Historical Architectural Review Board COA Preliminary Review Sheet

HDC-2025-00046

Address: 1022 Chew Street

Proposal: Construct a third-floor dormer addition at the rear of the house

Proposed Dormer Addition (Applicant)

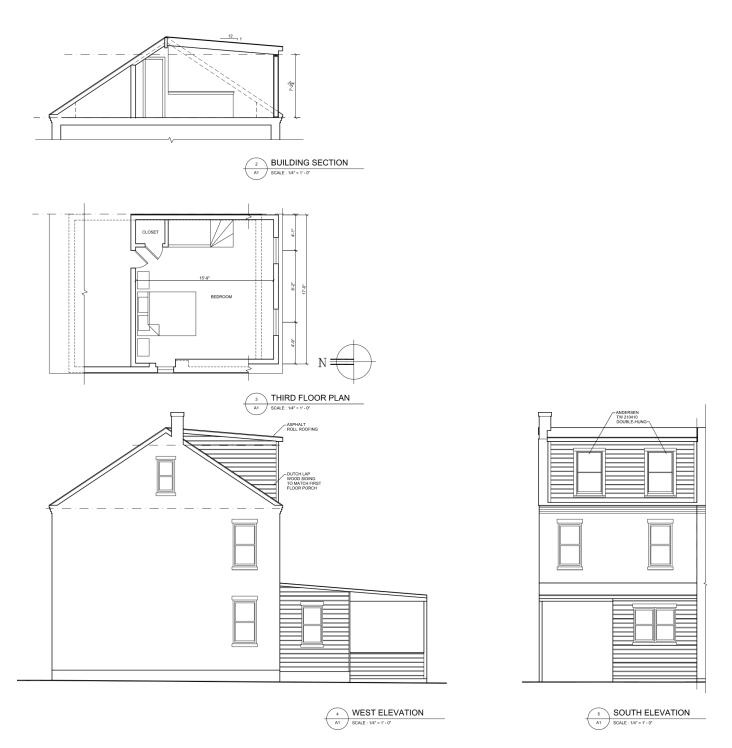
- A dormer addition at the rear of the building is an appropriate location. There would be some visibility from Howard Street, and from Zieglers Court at the rear. It is not clear if the dormer would be completely obscured from view along Chew Street, or if it would be only minimally visible.

- The proposed dormer does occupy a majority of the rear roof. It would be helpful to understand if it is possible to reduce the overall width and/or length of the dormer.

- The proposal indicates two windows in the dormer. The 1/1 configuration is in keeping with the other windows on the building. More information would be helpful, including the materiality of the window, and overall dimensions. It appears that the windows are larger than the existing second floor windows, which does not follow the typical proportion of windows in dormers, which is that dormer windows are smaller than primary windows.

- The proposed siding is wood Dutch lap siding to match the rear first floor area. Wood lap siding is appropriate per the Guidelines. Per the Guidelines, all wood elements are to be painted.

- Gutters and downspouts were not included in the application materials. More information would be helpful to understand if these elements are intended to be included, and if so, the materials and profiles of those items.

- The dormer footprint is reduced in size in width and/or depth, so as to occupy less of the rear roof slope and be in a more similar proportion to other original dormers in the area.
- Window materiality is in keeping with the Guidelines.
- All wood elements are painted.
- Any proposed gutters and downspouts for the dormer are submitted for approval.

The applicant stated that the dormer is not the full width of the roof – it is set off 18" from the Howard Street edge of the roof. There is an existing stair that influenced the dormer width. Any reduction in width would have to be taken from the Howard Street side. The applicant noted that the dormer would only be seen from a pedestrian standpoint and would only have limited visibility. The intent of the dormer is to create a more usable third floor in the building.

The HARB discussed that the dormer is appropriately placed on the rear roof slope. The dormer width is to the interior face of the party walls. The materiality of the windows could be wood, aluminum clad wood, or fiberglass. The gutter on the dormer would be a half round with a round downspout.

Mr. Hammond noted agreement with recommended staff conditions but removing the first condition about the reducing the size of the dormer. The board was in agreement that the size of the dormer is appropriate, given the stair location in the interior and nearby building configurations.

- o Window materiality is in keeping with the Guidelines; wood, aluminum clad wood, or fiberglass.
- All wood elements are field or factory painted.
- Any proposed gutters and downspouts for the dormer are half round gutters and round downspouts, in keeping with the Guidelines, subject to staff approval.
